City of Hollywood Planning Division 2600 Hollywood Boulevard Hollywood, FL 33020

Based on your Preliminary TAC Review comments dated February 20th, 2018 Keith and Associates (K&A) offers the following responses to your comments/questions:

6 – Final TAC Comment Responses

FIRST FLOOR PLAN - WEST BUILDING

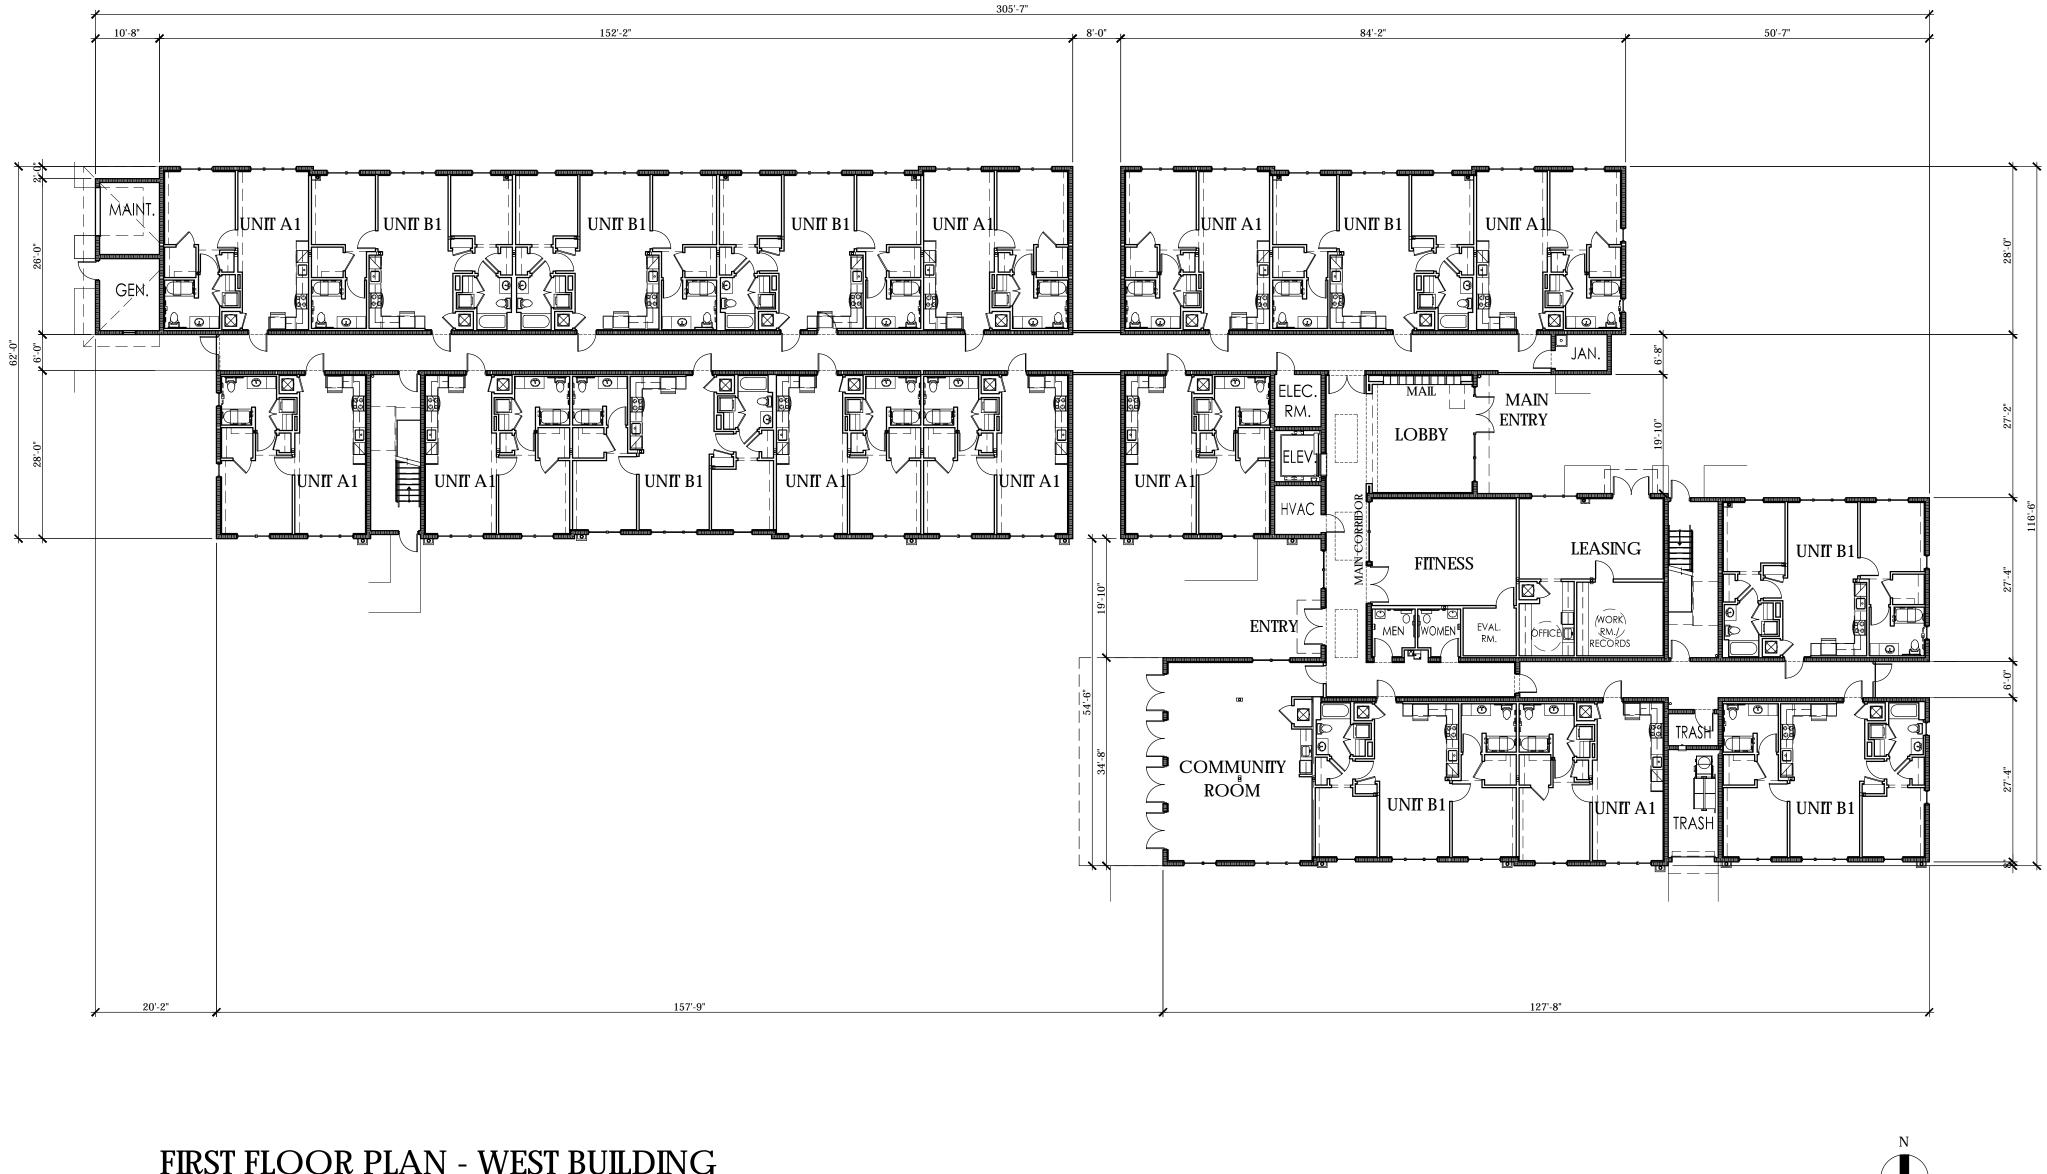
1. The trash room is located behind a roll up door, but I do not see a floor plan for the trash room. Also, how is access provided? Is trash collected down a chute or is there a door for residential access. These comments are relevant to all three sites.

RESPONSE: There are trash cutes on the second and third floors in each building, in the same location. The first floor has a direct chute to a trash container in the trash room. These spaces are demonstrated on the Building Plans Sheets A 2.0 through A 2.6 and an enlarged plan on sheet A 3.6.

FLOOR PLAN - UNIT B2 (UFAS) SCALE 1/4" = 1'-0"

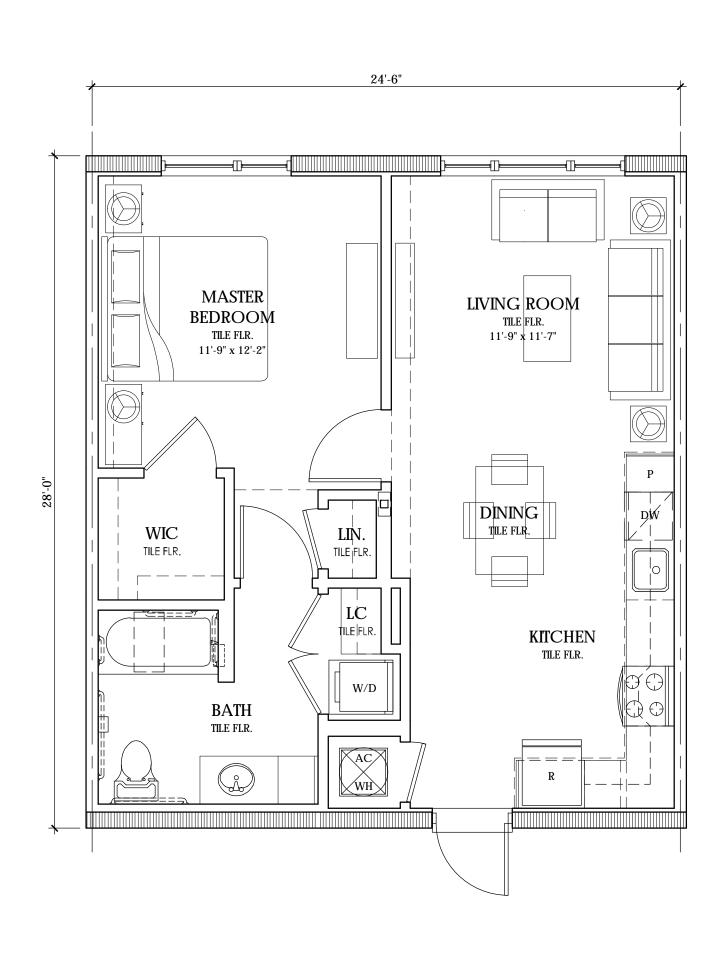
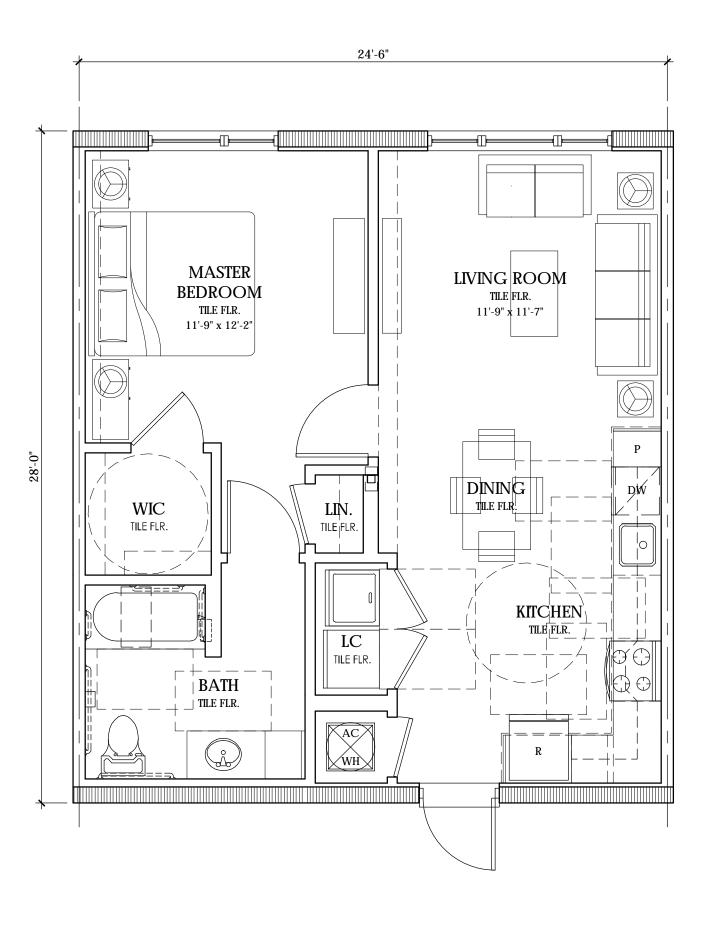
Provide room dimensions of the apartment units

RESPONSE: We have added sheet A 3.0, Unit Floor Plans which demonstrates the dimensions under the room titles.

WEST BUILDING - NORTH (ADAMS ST.) ELEVATION SCALE 1/16" = 1'-0"

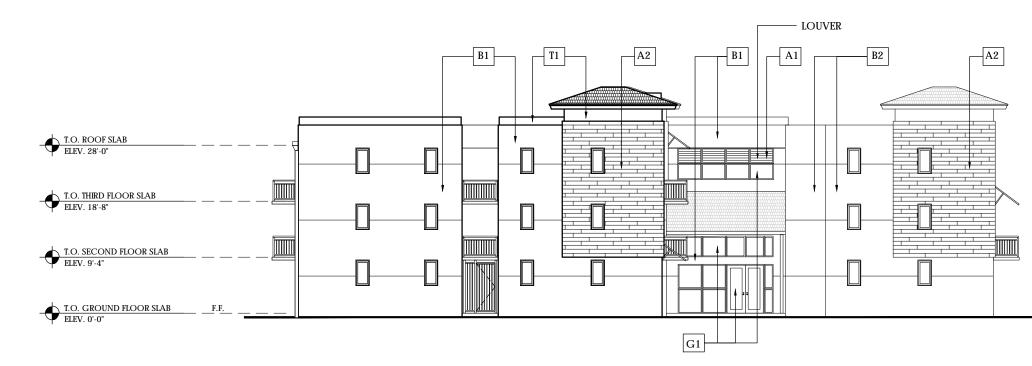
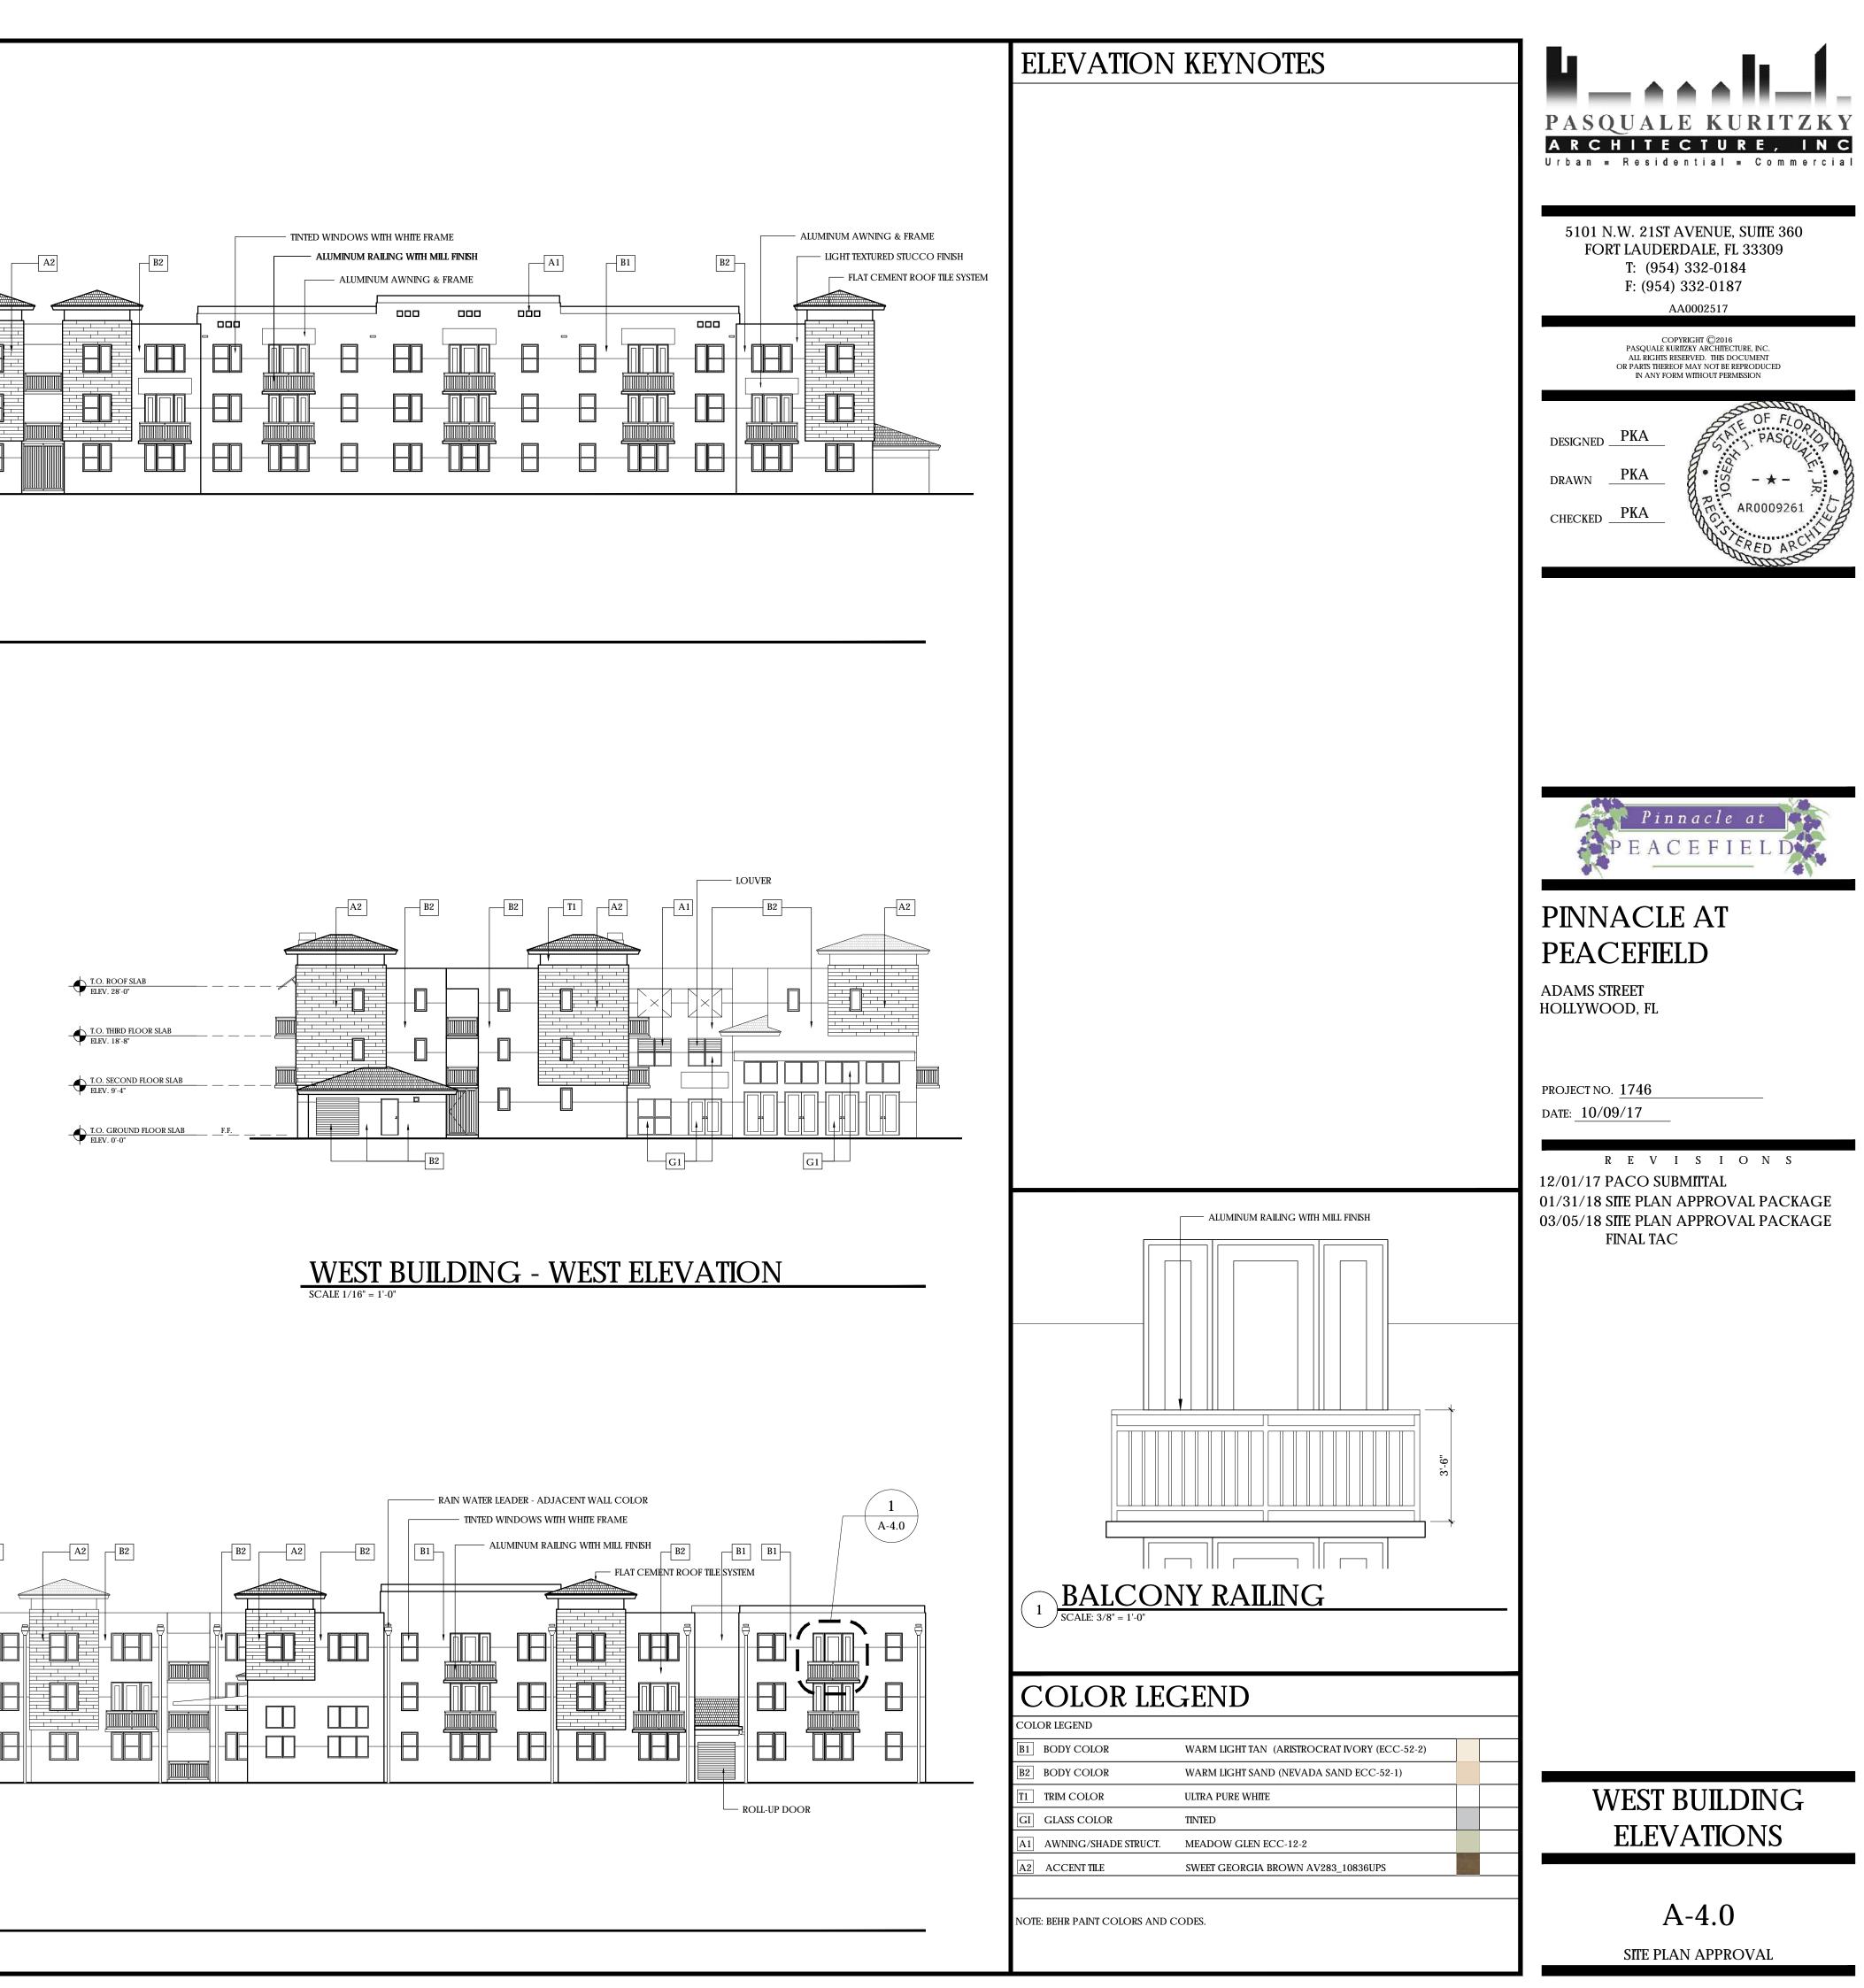
4. Sheet A-4.0 – Would prefer rainwater leaders not face the street.

RESPONSE: Exterior rain water leaders have been removed from the front elevation, and will appear on the rear elevation only as discussed during the February 20, 2018 TAC Meeting. See comment C(1).
